Docket Item # 1  
BAR CASE # 2011-0041

BAR Meeting  
March 16, 2011

**ISSUE:** Certificate of Appropriateness  
(Alterations to an Existing Enclosed Porch)

**LOCATION:** 428 North Columbus Street

Revised Alternate Submittal

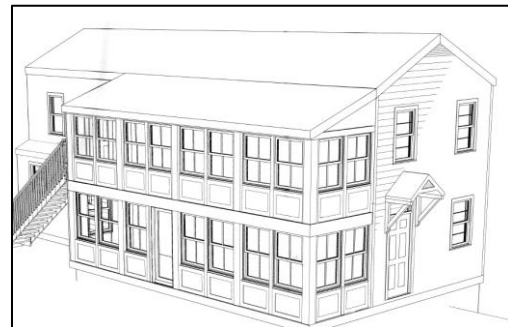
The original submission featured pairs of two-over-two double-hung windows above individual panels, with each pair of windows divided by simple pilasters. The applicant has since met with Staff and simplified the design by creating one larger panel beneath each pair of windows, in order to emphasize the bay spacing of the porch columns. However, the applicant has requested the option of dividing the panels below the windows into two separate panels upon a field determination of which appears more appropriate. Because this is a minor change to the overall project proposal and both are considered generally appropriate, Staff is comfortable working with the applicant in the field to determine whether a single or double panel is most appropriate once construction begins.

1. That the applicant may opt to use either one or two panels below the paired windows after determining with Staff the more appropriate choice in the field; and
2. That the applicant submit door and window specifications that meet the Alexandria Replacement Window Performance Specifications prior to issuance of a building permit.
